WILLIAMSON COUNTY, TEXAS  
 CHANGE ORDER NUMBER: 2

Project:	<u>1805-229</u>
Roadway:	<u>Bagdad Road at CR 278</u>
CSJ Number:	<u>                    </u>

**Bagdad Road at CR 278  
Williamson County Project No. 1805-229**

**Change Order No. 2**

**BAGDAD RD AT CR 278  
PLAN & PROFILE  
BAGDAD ROAD  
STA. 549+00 TO  
STA. 556+00**

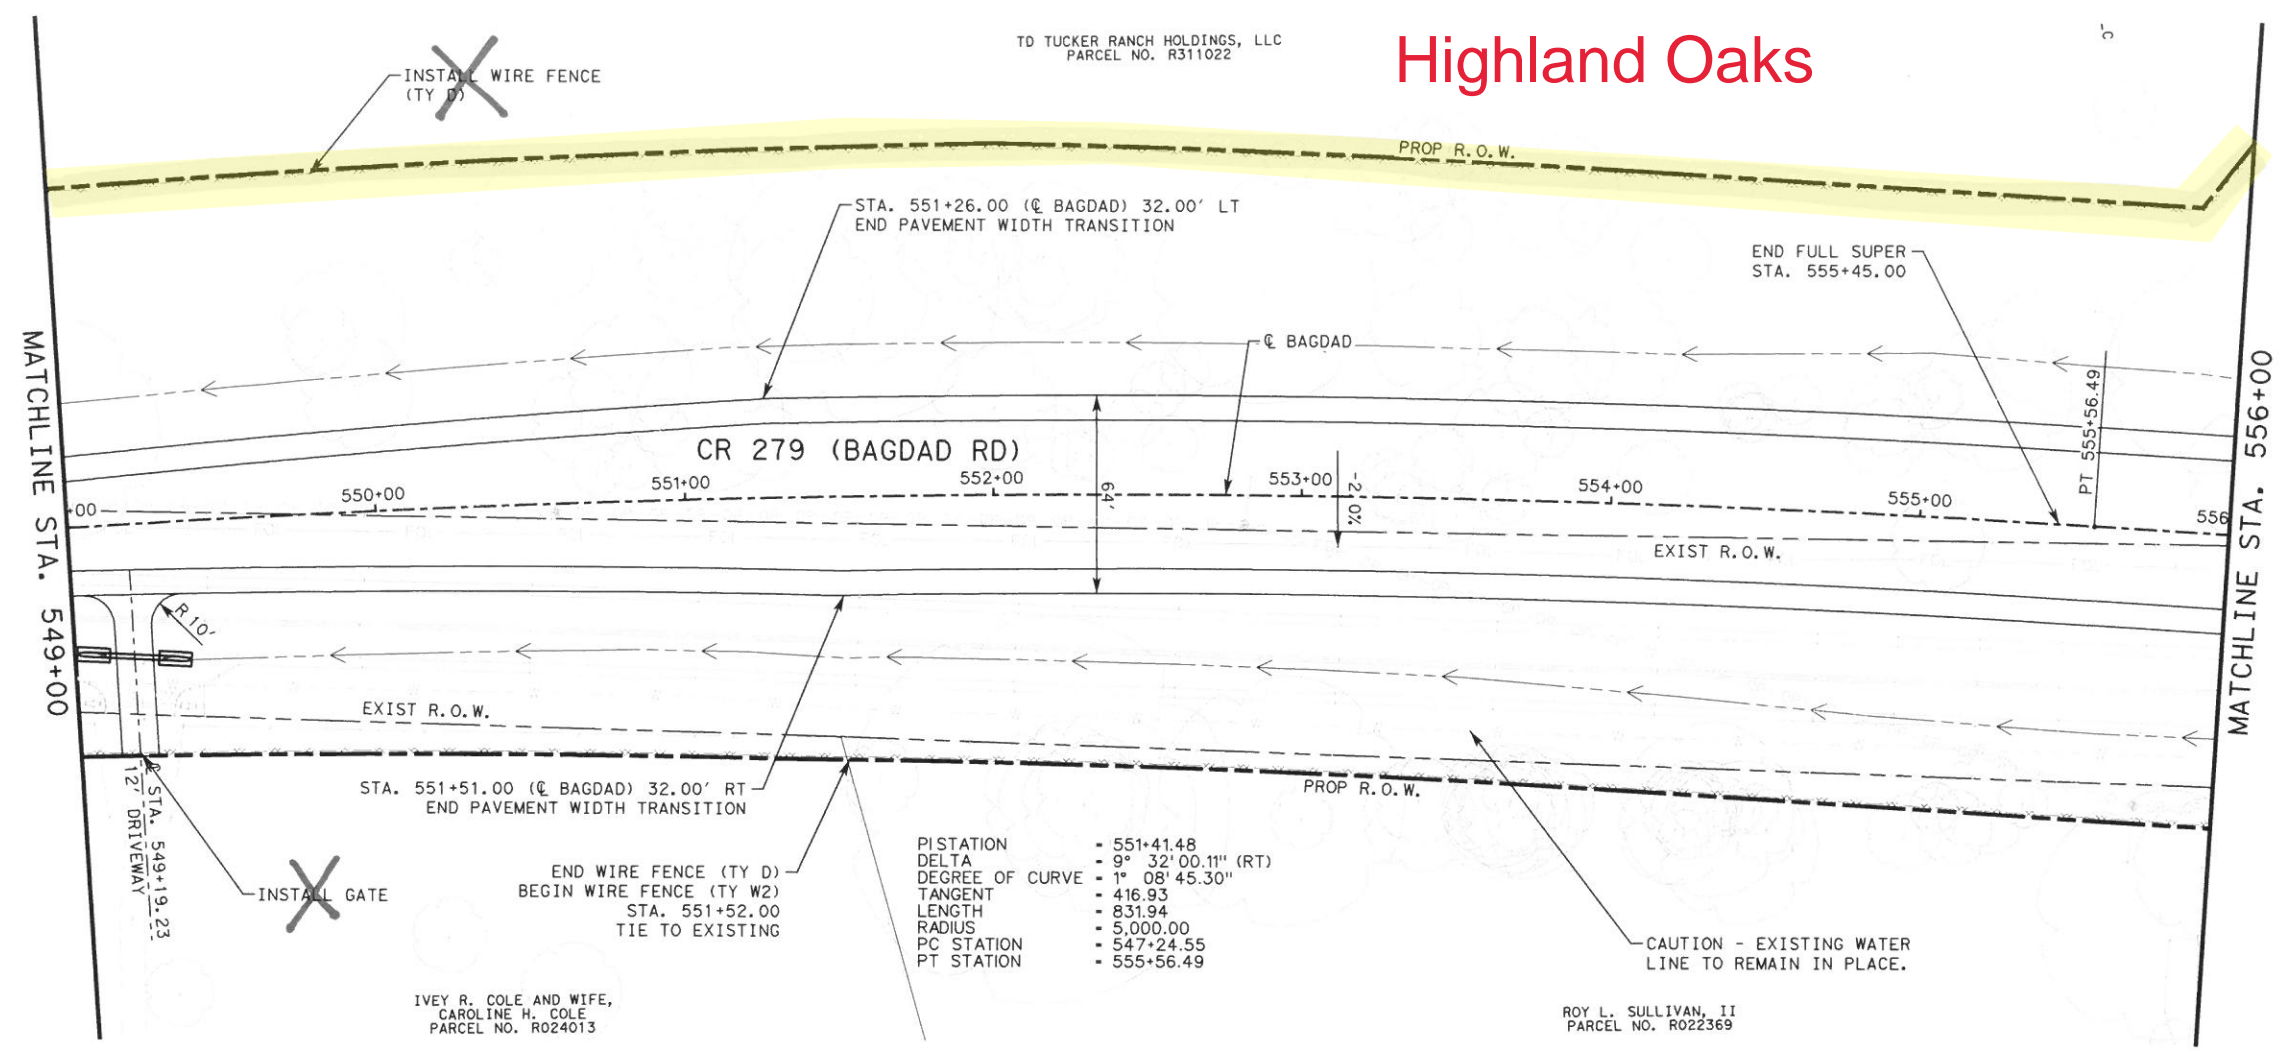
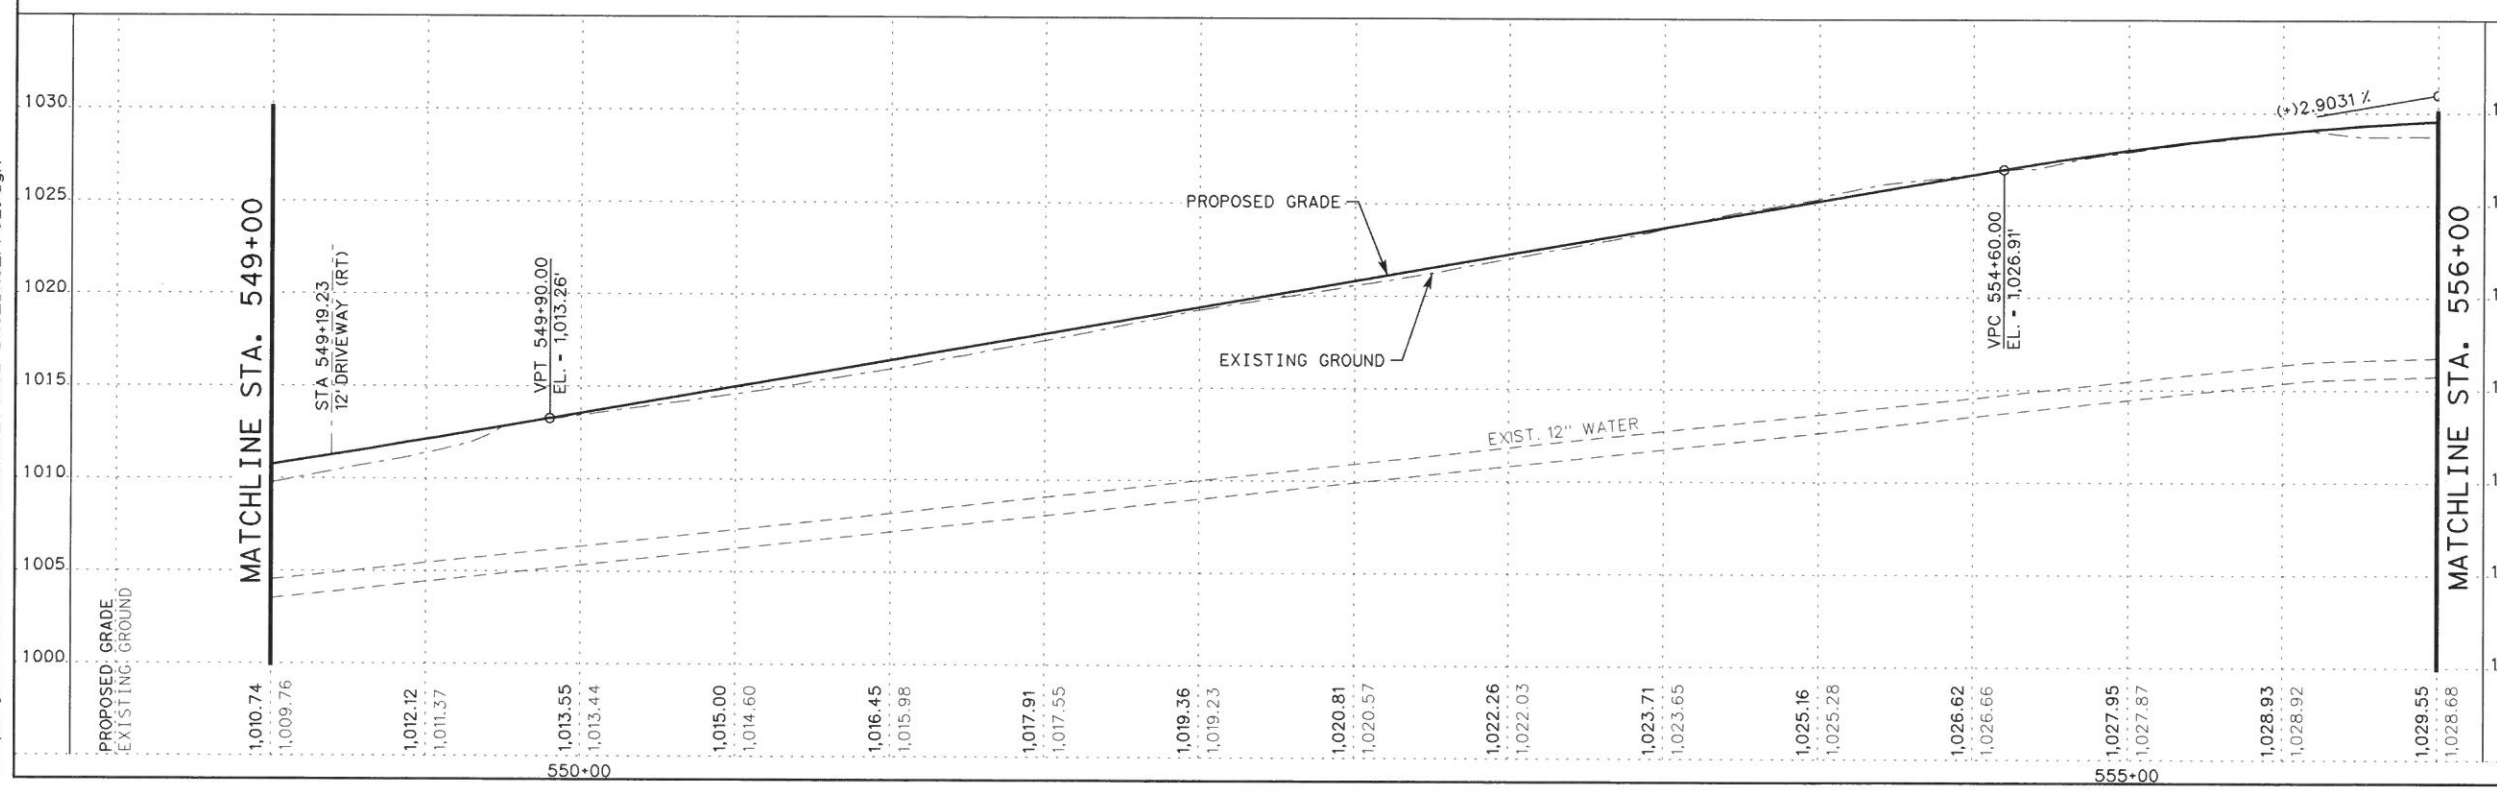
**3F: County Convenience. Additional work desired by the County.** This Change Order adds new property fence on the south side of the River Ranch Park Road to replace the existing old wire fence as requested by the County's Parks Department. **2E: Differing Site Conditions (unforeseeable). Miscellaneous difference in site conditions (unforeseeable)** This Change Order adjusts the quantities of Type D fencing and Type 1 gate as a result of addressing difference in site conditions. The proposed wire fence and gate on west side right of way in front of Highland Oaks subdivision is no longer needed. Also, the driveways at Sta 549+19 and 566+64 have recessed gates and do not require new gates to be installed.

This Change Order also adjusts the quantities of Type D fencing and Type 1 gate as a result of addressing field conditions not accounted for in the original plans. The property between Silver Creek Dr. and River Ranch Park was turned into a subdivision and the proposed wire fence and gate on west side right of way at this location is no longer needed. Also, the driveways at Sta 549+19 and 566+64 have recessed gates and do not require new gates to be installed.
